**SITE PLAN REVIEW SHEET
ENVIRONMENTAL VARIANCE REQUEST ONLY**

CASE: SP-2019-0108D

PROJECT NAME: Thaxton Road Tract Offsite Wastewater Improvements

**ENVIRONMENTAL COMMISSION MOTION 20191106 008b**

THAXTON ROAD
OFFSITE WASTEWATER LINE
6810 COLTON BLUFF SPRINGS RD
OVERALL PROJECT INDEX MAP

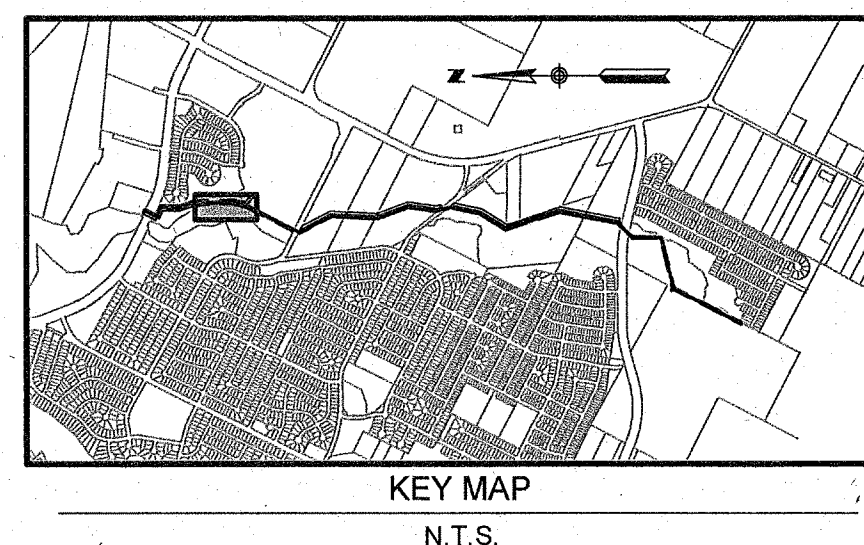
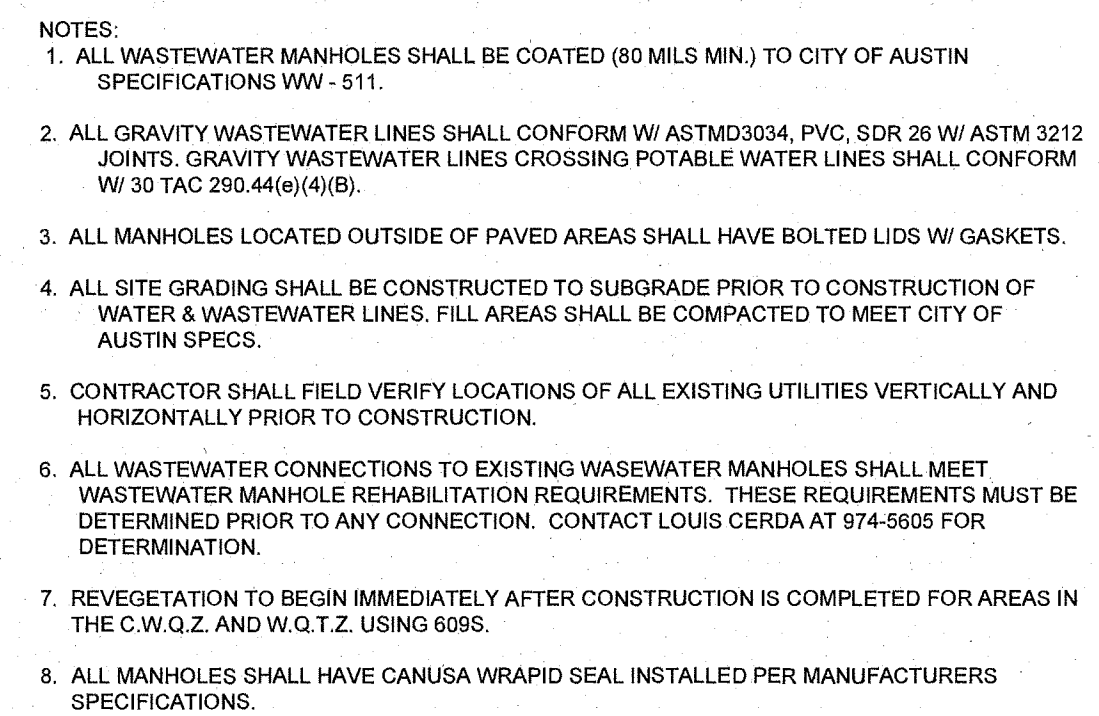
No. The wastewater line is proposed within a dedicated easement that was not reviewed and approved by environmental review staff of the Development Services or Watershed Protection Departments prior to dedication. The proposed wastewater line would encroach into the erosion hazard zone and an area that is less than the minimum 150 feet setback from the center line of the adjacent major waterway (Marble Creek). An easement dedication does not guarantee the right to construct a utility otherwise prohibited by the Land Development Code.
 2. The variance:
 - a) Is not necessitated by the scale, layout, construction method, or other design decision made by the applicant, unless the design decision provides greater overall environmental protection than is achievable without the variance;

No. Alternative alignments that would not encroach into the minimum setback of the critical water quality zone exist. However, the applicant intends to take advantage of an already dedicated easement and provide a gravity-fed wastewater line, rather than dedicate a new easement within the right-of-way and provide a force main line with lift stations, as needed. As proposed, the wastewater line will result in permanent alteration of the critical water

quality zone and does not provide greater overall environmental protection because of the potential for leaks and breaks in the line resulting in sewage overflows into clean-flowing creeks.

No. There are alternative locations for the wastewater line and access road that would not necessitate a variance.

No. As currently designed, the proposed wastewater line construction intends to bore under the critical water quality zone and the erosion hazard zone, with an overall approximate average depth of 8-12 feet, resulting in disturbance to subsurface hydrology and removal of native soils. The proposed wastewater line will require future repairs from eventual breaks and sewage overflows, which will require trenching to repair the line that equates to removal of riparian vegetation and disturbance to hydrologic functions.

No. Staff has made the determination that because an alternative route and method of construction are available to provide wastewater utility service, the proposed location of the wastewater utility within the minimum setback of a Critical Water Quality Zone and the erosion hazard zone does not meet the criteria for granting a variance in Subsection A.

1. For the proposed wastewater line, access roads shall be minimized to the maximum extent practicable within the critical water quality zone, including during time of construction or future maintenance.

2. For the proposed wastewater line, the utility alignment crossing the creek shall bore under the creek and encase the line, and the bore and receiving pits shall be located outside of the erosion hazard zone.

3. For the proposed wastewater line, no amount of the stabilized construction entrances shall be located within 150' of the creek centerline.
4. The waste water line shall be encased within all areas of the inner half of the Critical Water Quality Zone.

5. The developer shall provide riparian revegetation for all areas in the inner half of the Critical Water Quality Zone and erosion hazard zone.
6. The developer shall avoid placement of manholes in the inner half of the Critical Water Quality Zone where feasible.

7

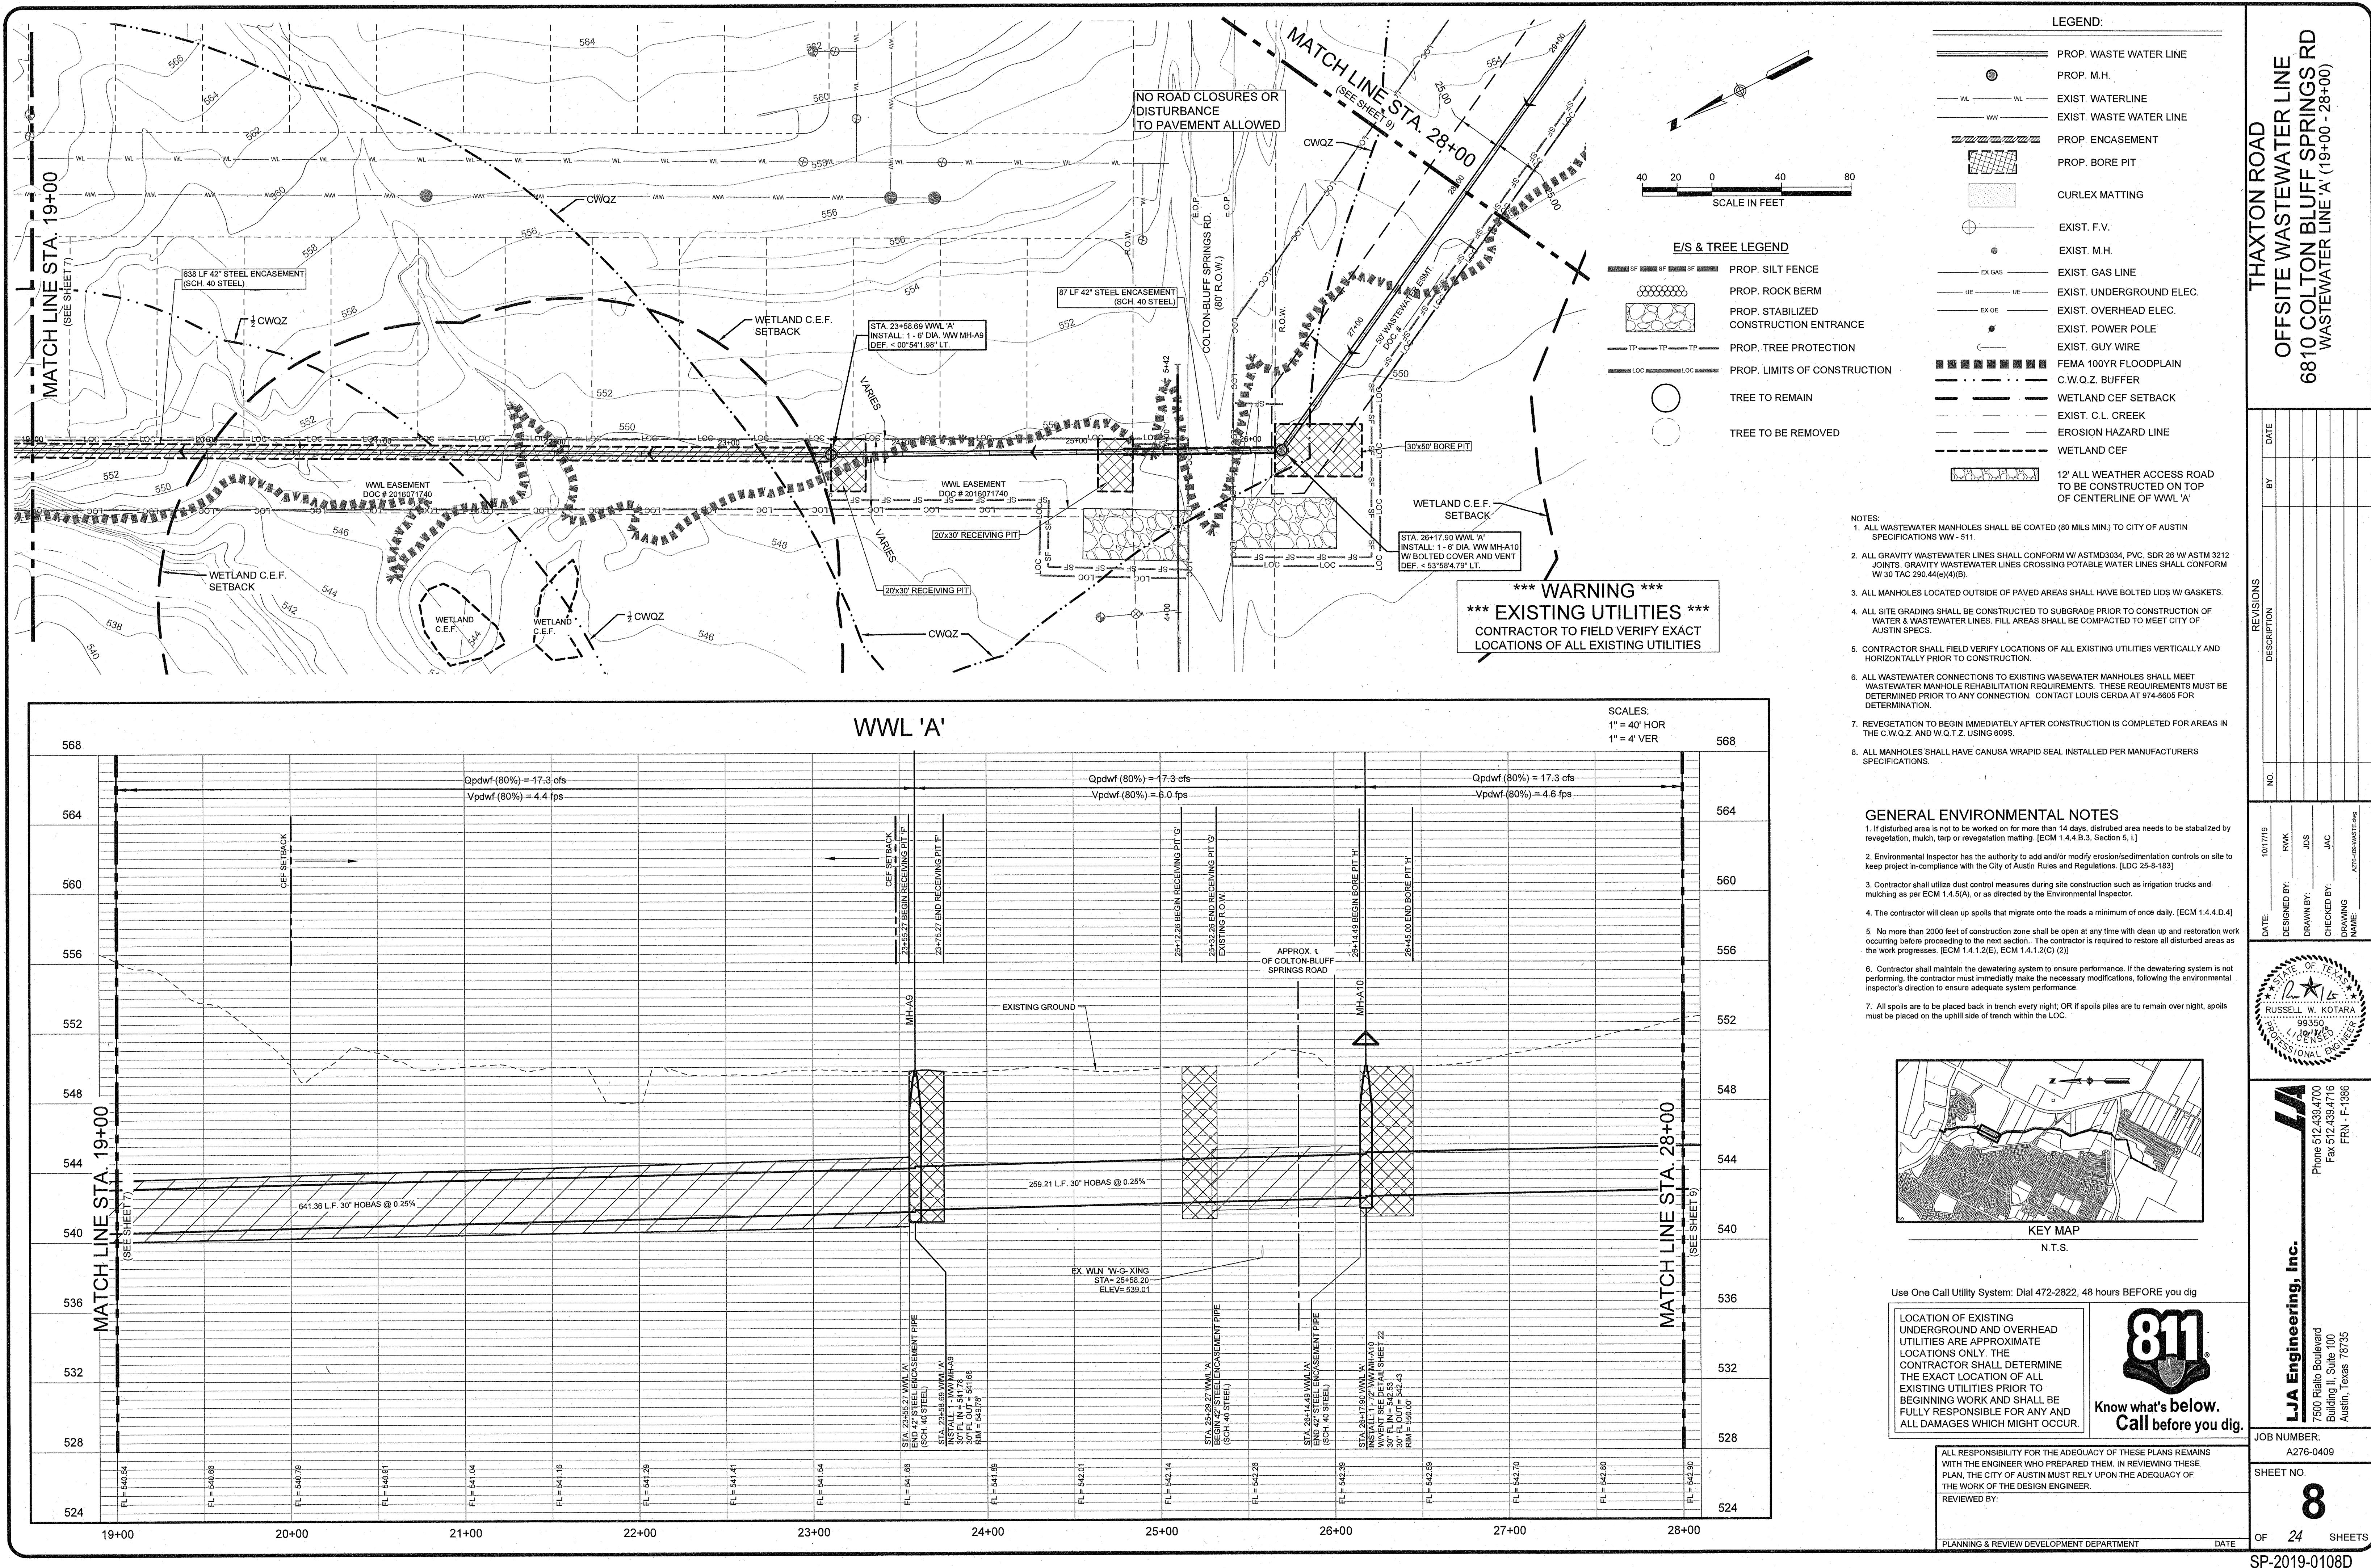
Clearly indicate in what way the proposed project does not comply with current Code (include maps and exhibits)	<p>The project includes a section of gravity wastewater line proposed with an existing easement that is located parallel to and within the CWQZ within 150 feet of a major waterway, which is not allowed under 25-8-261 (E) of the Land Development Code.</p> <p>Please find attached exhibits documenting proposed variance.</p>
---	--
